RENESAS TECHNICAL UPDATE

Product Category	System LSI		Document No.	TN-RZ*-A0059A/E	Rev.	1.00
Title	Advanced 5port Switch (A5PSW) register write access issue		Information Category	Technical Notification		
Applicable Product	See below	Lot No.	Reference Document	RZ/N1 Series User's Manual (See below for details)		
		See below

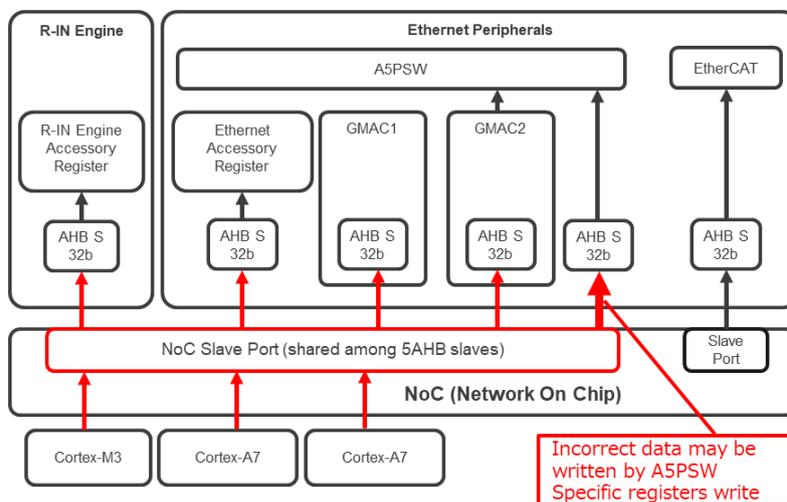
- "R1" marking will be added left side of MADE IN marking on the PKG.
